## ADDENDUM #1

### BELGRADE CENTRAL SCHOOL – SIDING REPLACEMENT PROJECT

07 October 2022

**OPENING TRIM DETAIL**  
SCALE: 1 1/2" = 1'-0"

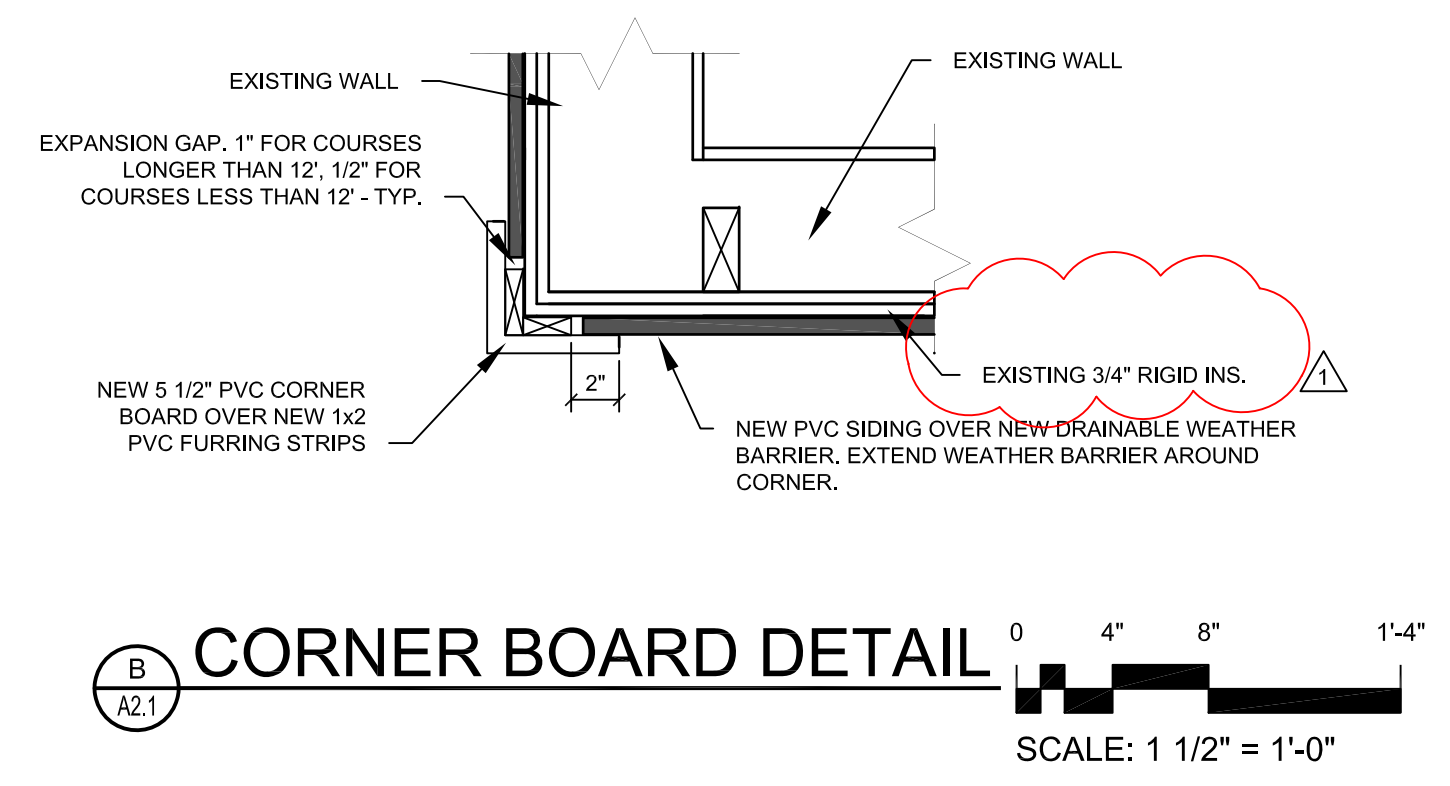
2. The drawing details depict using a “2-inch Celect J Channel”. The factory representative said that they do not offer such a product. The typical detail is to install the 1x2 blocking around the fenestration opening and then attach a 1x4 Celect PVC trim board to cover the required expansion gap. Please advise.

**The 2-inch Celect J-Channel has been changed to Brickmold/J-Channel 7351.**
